pd-trigger — Design Document

ai-ee v1 pipeline

Board review (P8 adversarial) - pd-trigger

5 Schematic

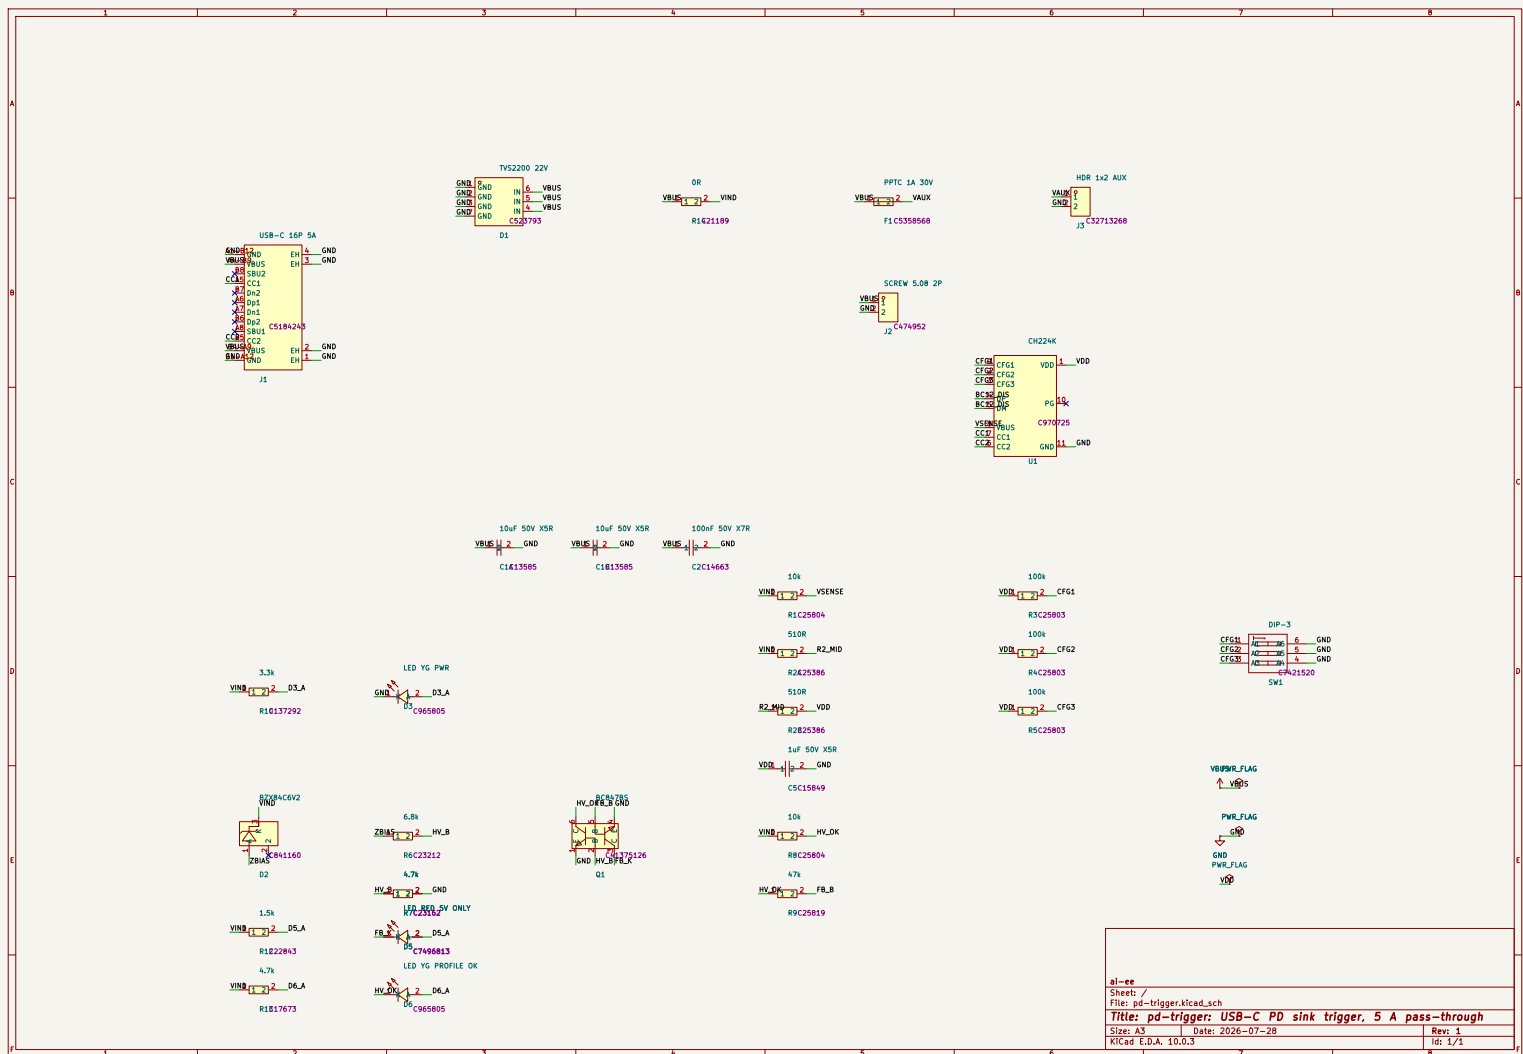
W1 dp-dm-short-at-chip: architecture’s PD-only short (`/BC12.DIS`) ACCEPTED by the reviewer as hardware-SAFER than the datasheet’s connector wiring (removes a 21V-onto-3.8V-abs-max fault path). Cost: no QC/BC legacy support - the board is “PD sources only”; goes on B.SilkS + order docs. W2 vdd-worst-corner: true worst case 0.979mA at 4.4V low-line all-straps- closed vs unpublished CH224K IDD - bounded by WCH’s own reference circuit; V1 bring-up step: measure VDD at the 5V profile; contingency = both 510R -> smaller (documented floor 600R total). Bring-up addenda: buzz out Q1 E/B/C once (clone PDF JS-gated; Nexperia- standard pinning verified as the compatibility claim).

reports/render_final/top.png

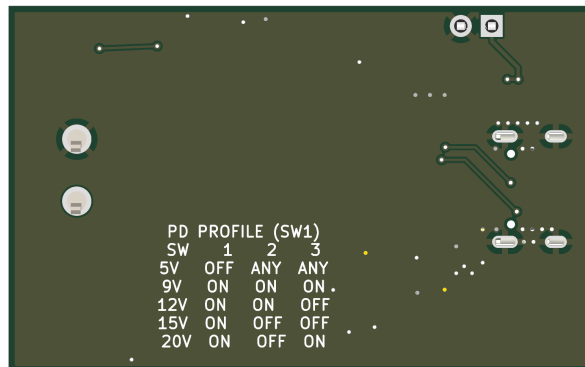
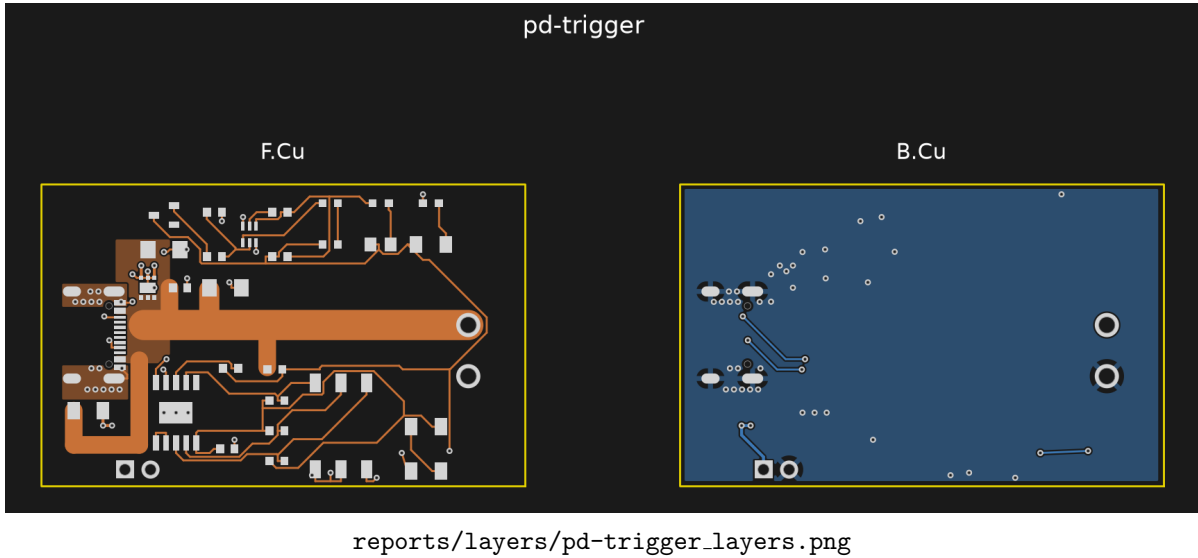
E1 - 5 A return chokes at J1's GND contact pads (error, checker-blind by design D7)

The 4 GND cable contacts land on two merged SMD pads (F.Cu only): A1-B12 at (17.63,39.31) and B1-A12 at (17.63,45.71), nominally 2.5 A each at the 5 A rating. Their ONLY copper into the B.Cu return pour:

- A1-B12 (top): a 0.2 mm wide, 2.7 mm long F.Cu chain (3 segments) into shell pad 1's THT barrel, plus one 0.6/0.3 via whose annulus grazes the pad corner by ~0.05 mm (etch-tolerance-level). 0.2 mm at 2 oz = 0.80 A capacity at 10 C rise (pipeline model); at 2.5 A the same model gives ~133 C rise (short-neck heatsinking will moderate this, but it is a >3x overcurrent on the model's own terms). ~13.6 squares = 3.3 mohm.
- B1-A12 (bottom): a 0.2 mm x 1.3 mm trace into ONE 0.6/0.3 via. The board's own via budget (constraints via_amps 0.5) says 2.5 A needs 5 vias; there is 1. Shell pad 4 sits 0.32 mm away but is NOT connected on F.Cu - its copper does not help.

Architecture D7/power_tree structural requirement ">= 10 vias at J1's GND pads" (the stated substitute for keeping GND out of power[] so check_current stays quiet): not delivered. DRC cannot see it (0.2 mm is netclass-legal), check_current cannot see it (GND undeclared), check_return_path no-ops (no high_speed key). Failure mode: sustained 5 A at any profile heats the two necks far past the 10 C design intent; long-term trace/joint fatigue, intermittent ground, and full return current cascading onto the surviving 0.2 mm chain. Fix is cheap at P9: an F.Cu GND spandrel bonding each contact pad to its shell pad (the VBUS pour top edge is at y 39.7 - the strip above it, and the strip x < 17.2 plus the region south of y 46, are free) plus 4-5 vias per side.

E2 - Safety/waiver silk markings absent (error, promised artifact) Board-wide gr_text count is ZERO; B.SilkS carries nothing at all (both B.SilkS references in the file are the stackup layer table). Missing, each one a written promise:

- AUX 1A MAX + V+/GND at J3 (P0 answer 4 "silk-marked", V10). F1 makes overload safe-by-hardware, but polarity of the 2-pin aux header is unmarked.
- PD SOURCES ONLY (ERC waiver W1's standing condition: "goes on B.SilkS + order docs"). The waiver's silk half is currently unfulfilled.
- J2 screw-terminal polarity. Trunk lands on J2 pad 1 = the LOWER screw (board-bottom side); nothing anywhere tells the bench user which screw is V+. Reverse-wiring a load on a 100 W output is the single easiest field mistake this board can cause.

- The five-row profile table on B.SilkS - D3 calls silk "the user interface" and specifies the table verbatim; the bottom is a clean pour with room. Without it the ON/OFF-to-voltage map exists only off-board; a user WILL set 9 V expecting 12 V by trial and error. (Fail-safe floor: any wrong guess >= the 5 V fallback, and OFF-fail = 5 V - the mistake is bounded but real.)

- LED legends PWR / 5V ONLY / PROFILE OK (D4/V10): the render shows refdes D3/D5/D6 only. The entire P0-answer-6 "visible fallback indication" scheme is mute without the words - a lit red LED labeled "D5" indicates nothing.

- User-facing reality: DIP reachable at top edge, actuators clear; J2 wire entry faces off-board (P6 WRL-verified rotation); J3 pluggable at top-left; LED row visible at bottom edge. All PASS mechanically - every labeling promise FAILS (E2/E3).

```
# P8 digest (pd-trigger)
verify PASS 8/8 first try. Fable reviewer: 4 err + 2 warn. Copper errors
REAL: 5A RETURN choked at J1 GND pads (0.2mm necks/0.80A, 1 via) - rebuilt
w/ priority-1 F.Cu GND lobes (connect.pads solid) + 15 new 0.6/0.3 vias ->
5.68A/4.70A per pad, 16 vias (D7 >=10 met). Removed 2 stitch vias 0.121mm
from THT drills - LIVE-PROVEN KiCad DRC blind spot (via-drill vs same-net
pad-drill never checked, finding 34). Silk errors: 17 texts added; agent
CORRECTED the orchestrator's B-table spec (raw CFG bits would be inverted
vs ON=GND switch reality - printed switch positions). Warns: mouth recess
-> order docs; outline 48x30 deviation recorded; C1B channels waived w/
numbers. Re-gates: drc_routed 0/0, verify 8/8. H4 AUTO-approved.
```
